Applicant: Lectrosonics, Inc.
581 Laser Road
Rio Rancho, NM 87124

Re: Response to Correspondence reference number 31740

Equipment: FCC ID: DBZSMQV, 731-confirmation number EA367770

Photograph showing separation distance from the back of equipment to the antenna.

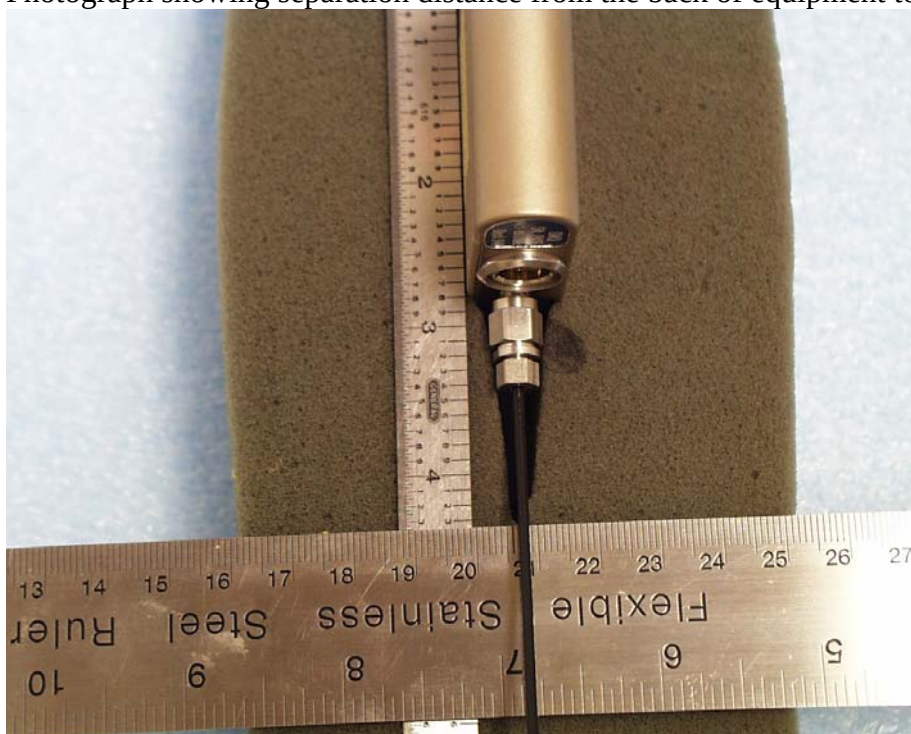
To support FCC RF exposure compliance determination, please submit photos and/or sketches for product with antenna installed showing spacings between the plane of the back of the belt-clip to: a) the back of the device, b) the closest point(s) of installed-antenna(s) FCC will then review all filing info to determine whether other info may need to be requested to support compliance with RF exposure requirements as applicable for all transmitters regulated by FCC. It may help to expedite this review if applicant has available and wishes to voluntarily submit SAR test results for this specific product

Below please find relevant photographs per your request demonstrating spacing between the back of the device and antenna, and the back of the clip and antenna.
